PROJECT: **City of Sterling Heights – Dodge Park Improvements**
Sterling Heights, MI

DMA PROJECT NO: **16078A**

ADDENDUM NO: **3**

ISSUE DATE: **July 7, 2017**

sheet no:
LS-2 of 5

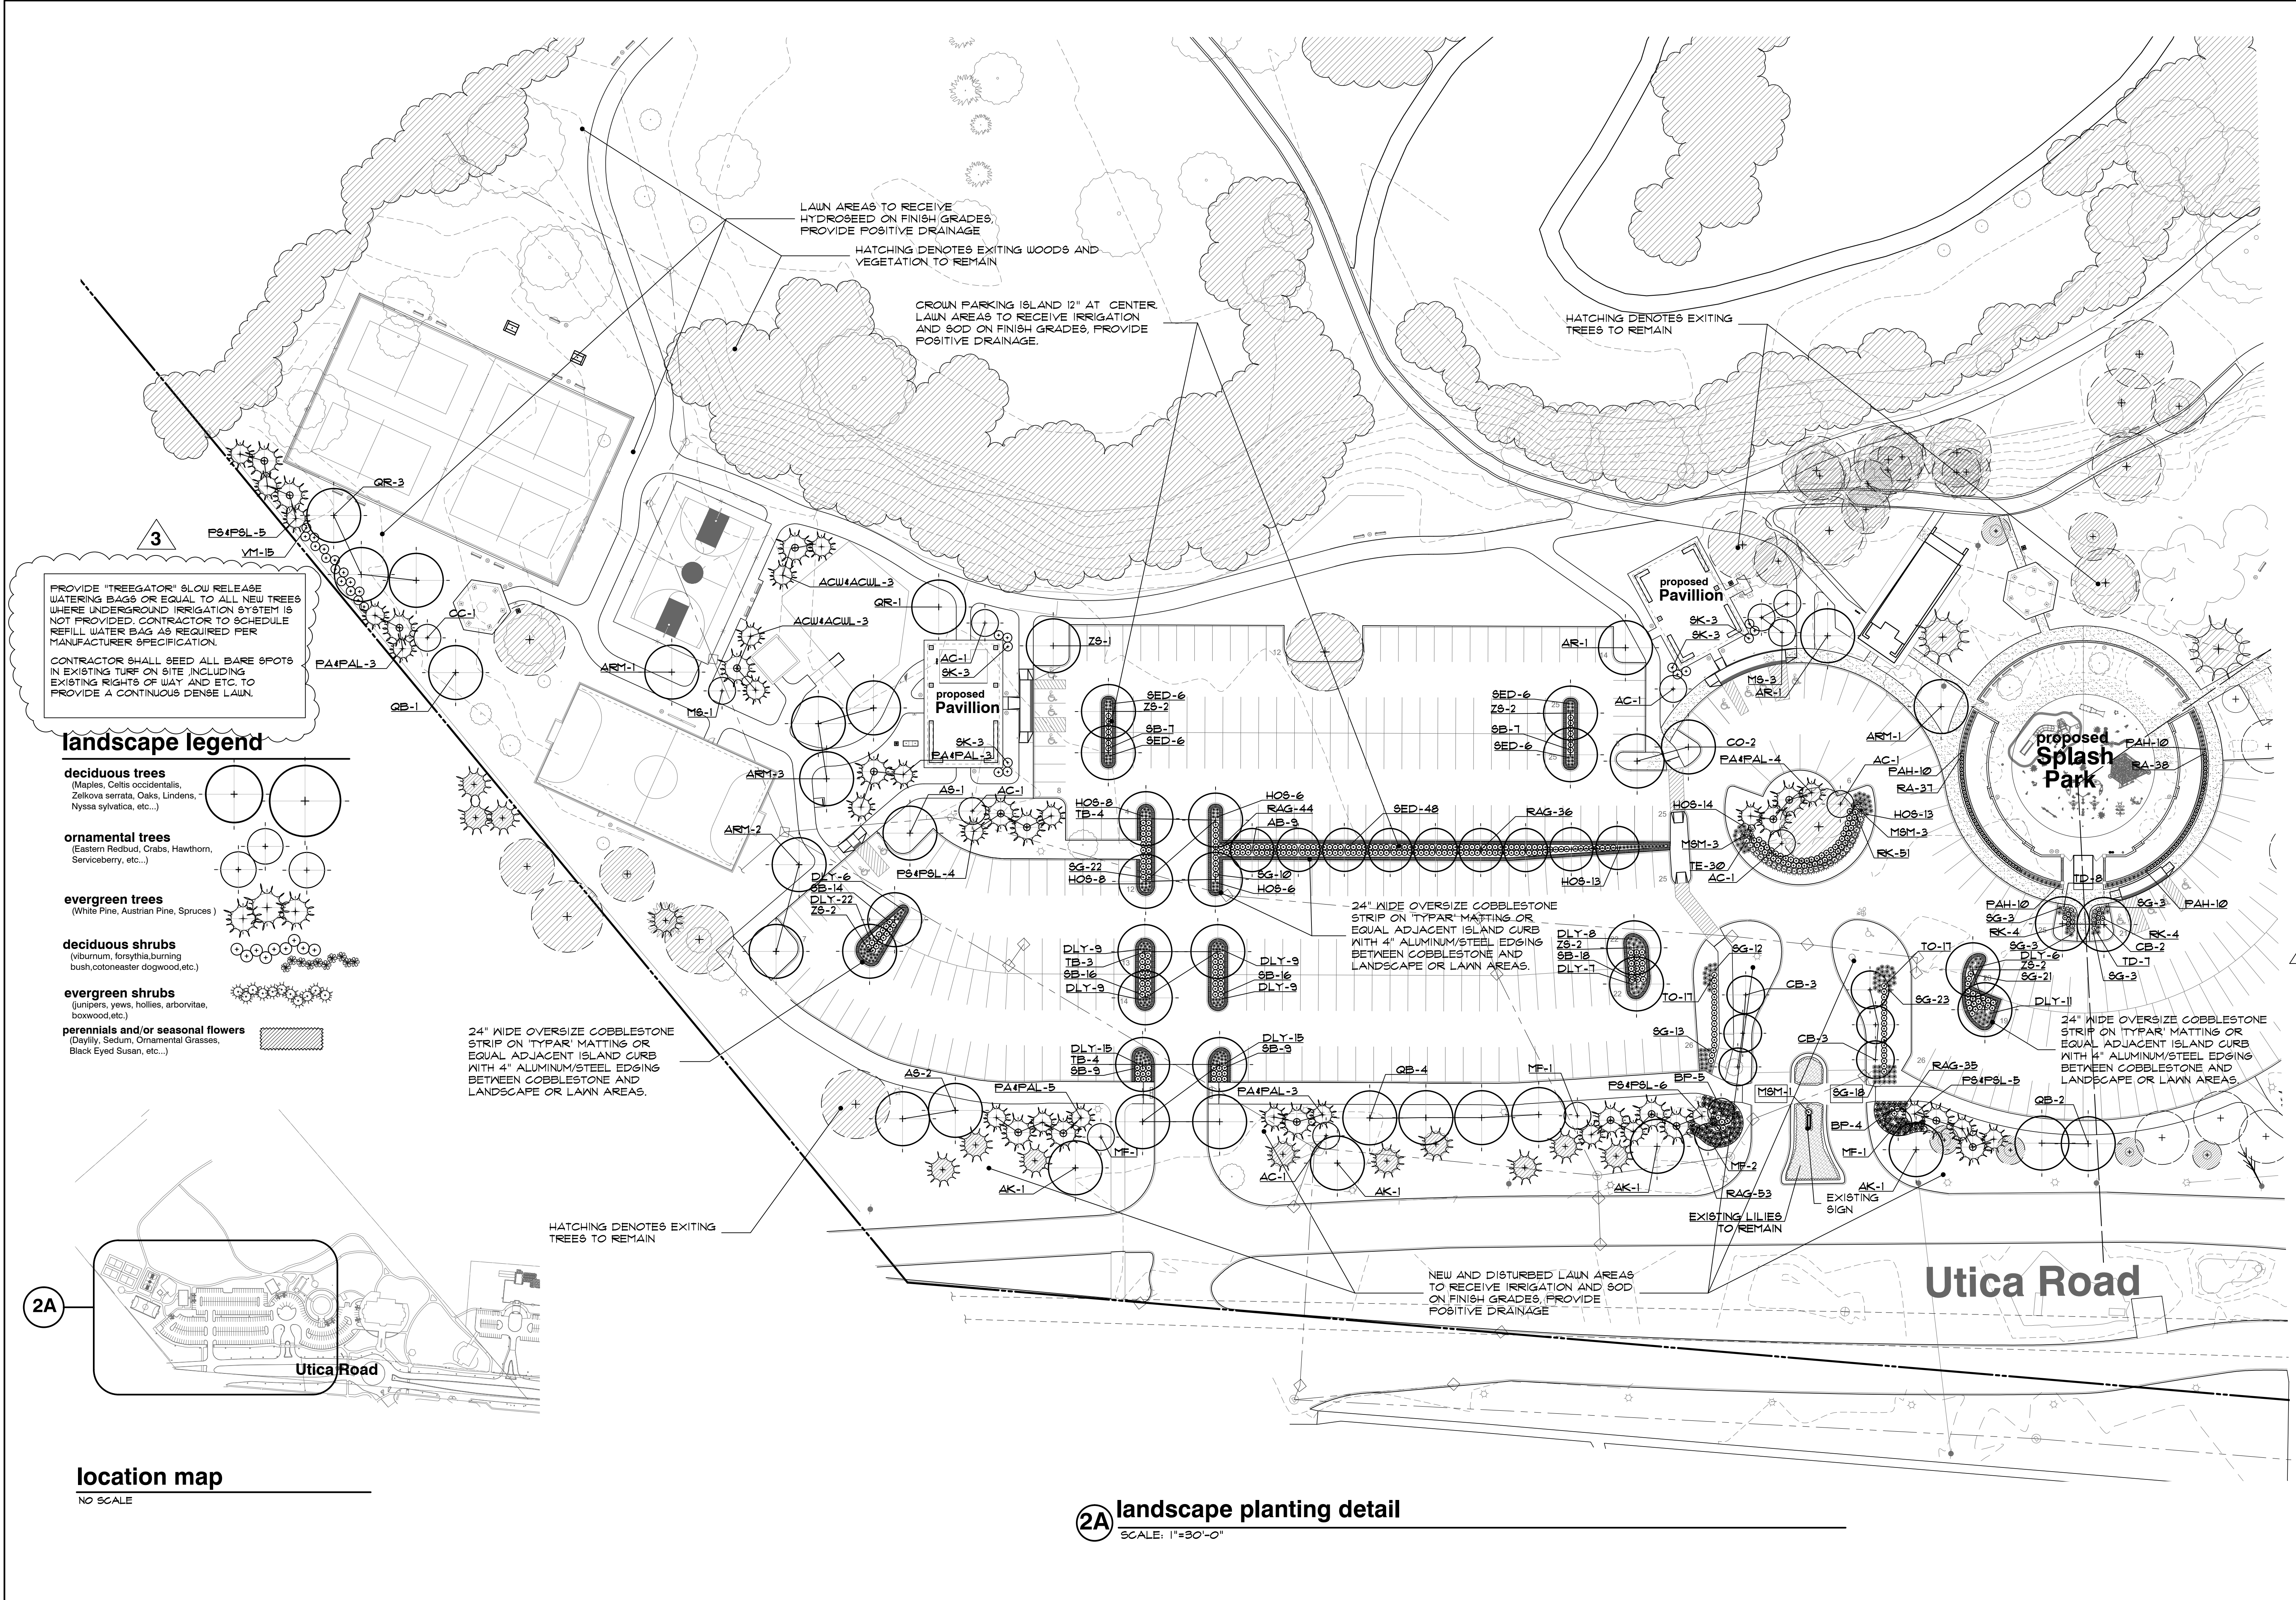
1. Revised sheet LS-1 to add “Treegator” slow release watering bags and seeding of bare spots in turf throughout site.
2. Revised sheet LS-2 to add “Treegator” slow release watering bags and seeding of bare spots in turf throughout site.

LS-3 of 5

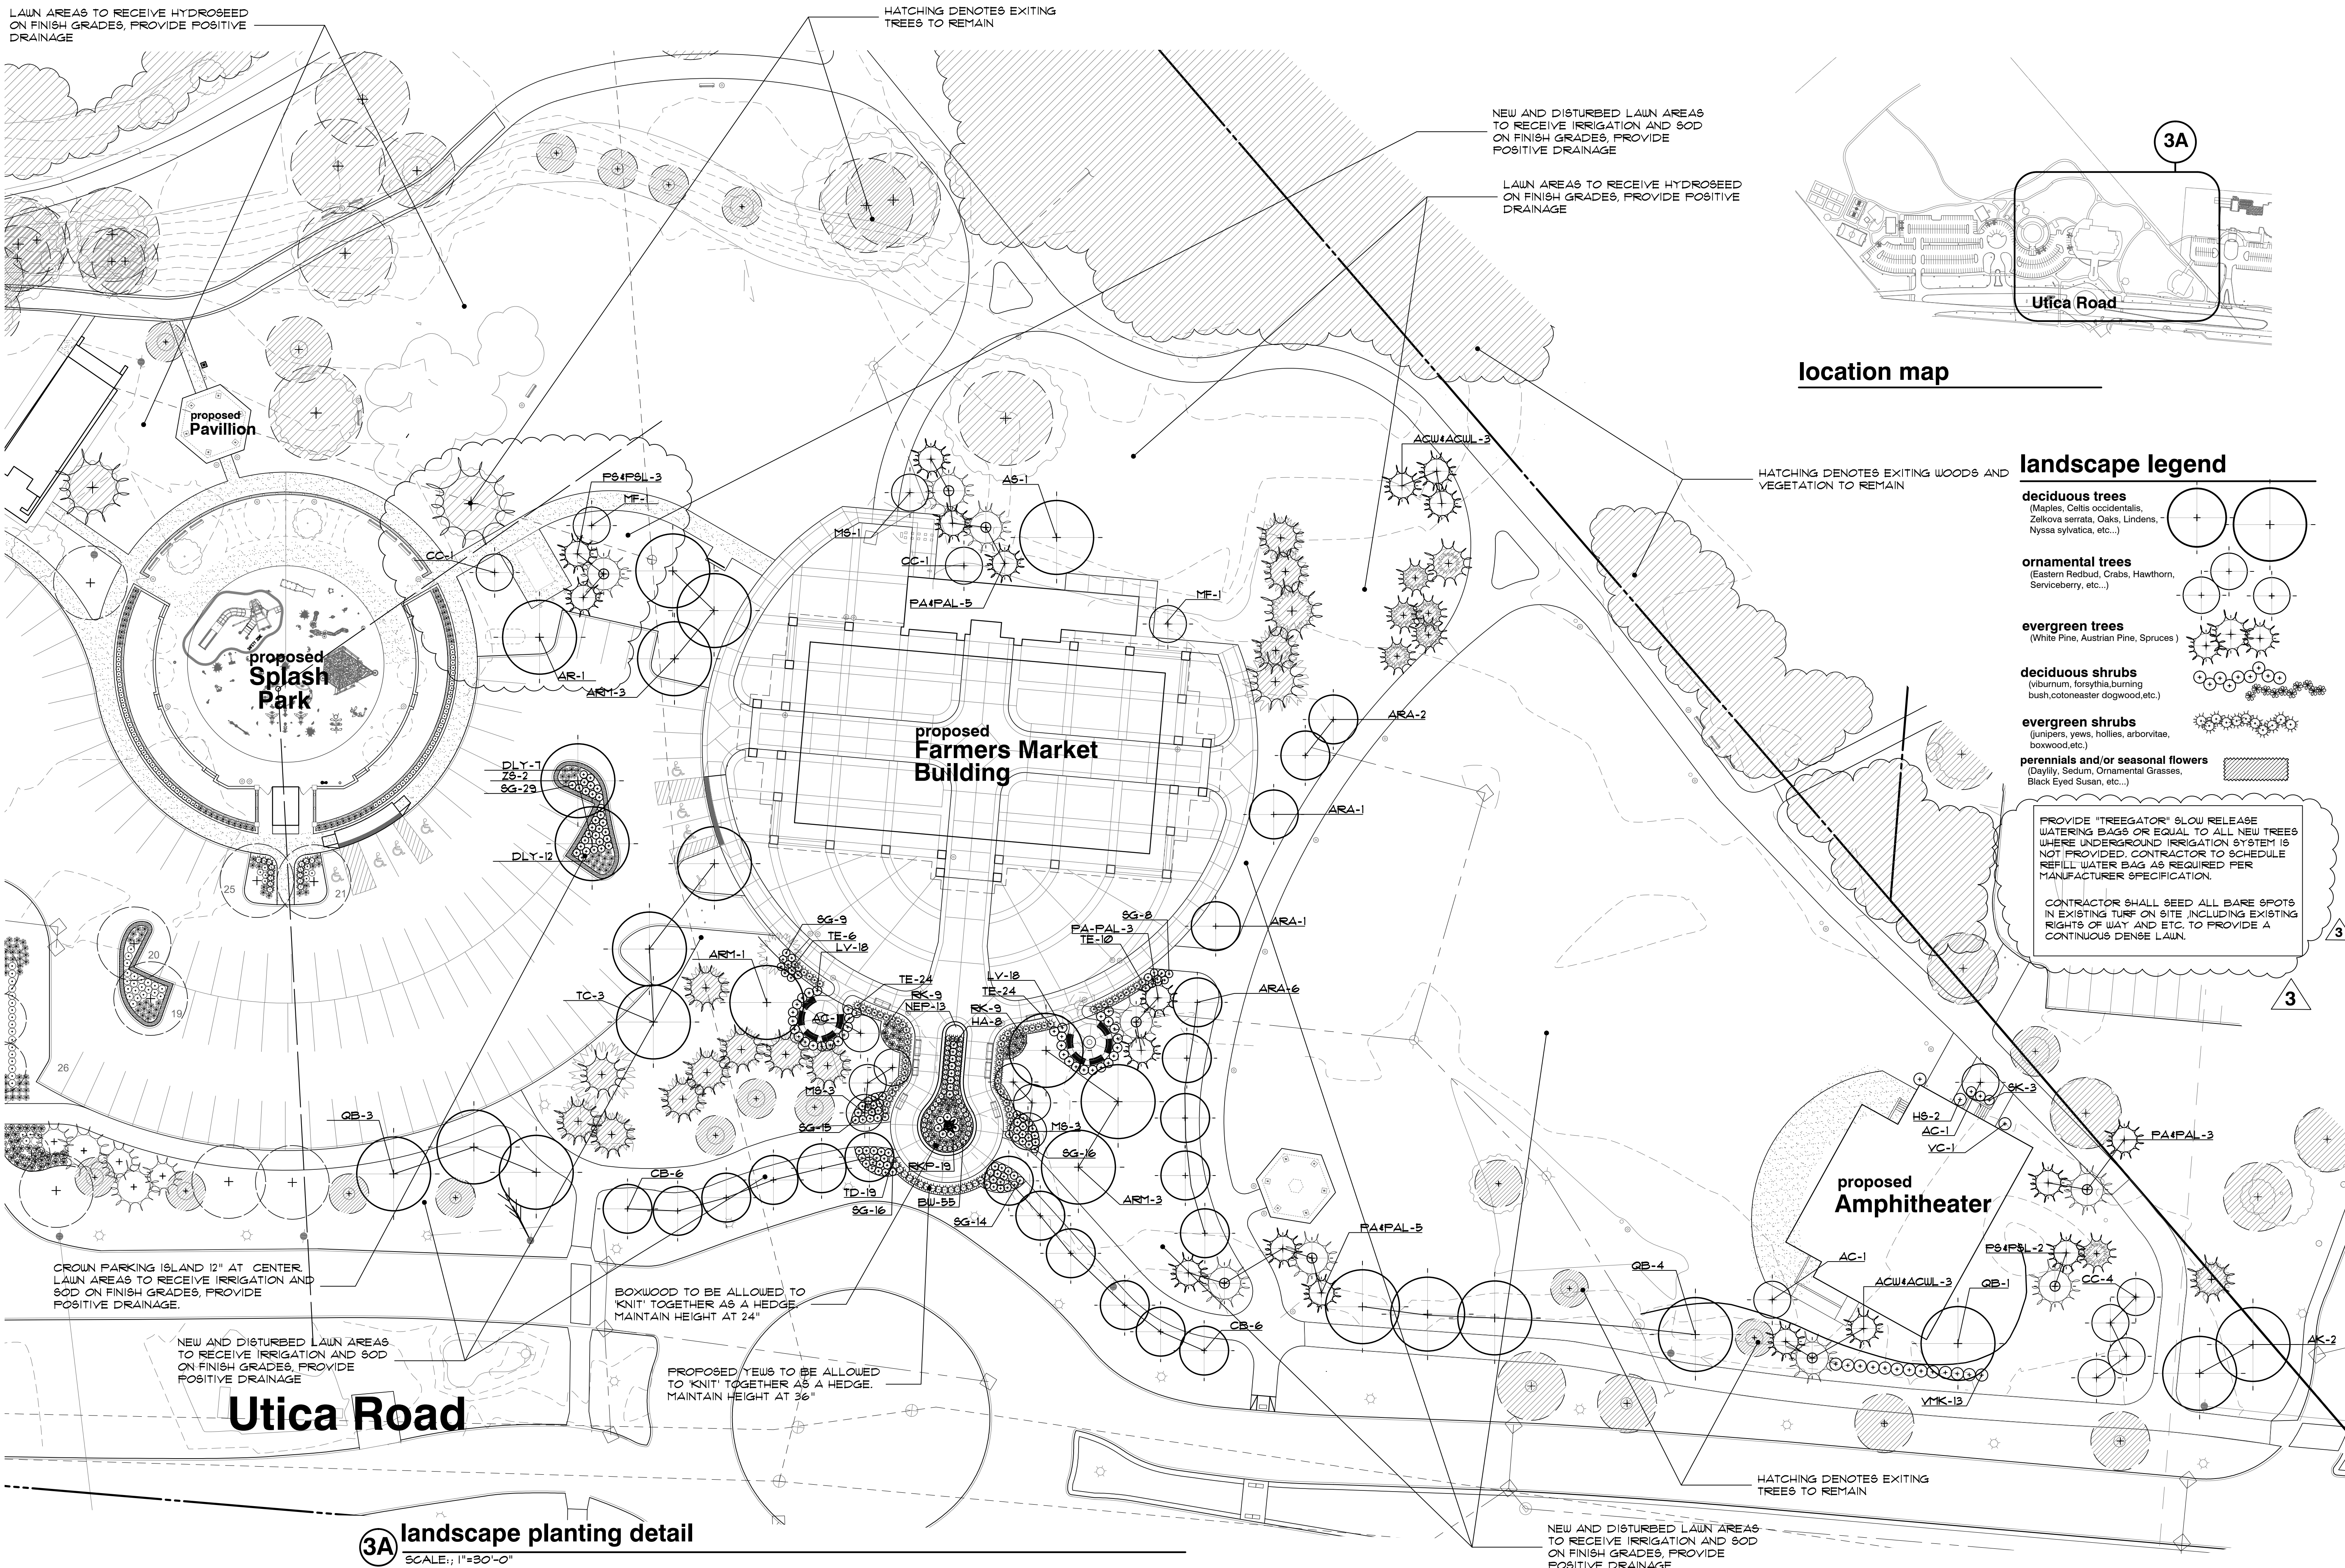
3. Revised sheet LS-3 to add “Treegator” slow release watering bags and seeding of bare spots in turf throughout site.
4. Revised sheet LS-3 to eliminate trees in the area to the east of the splash park to prevent conflict with the splash pad equipment.
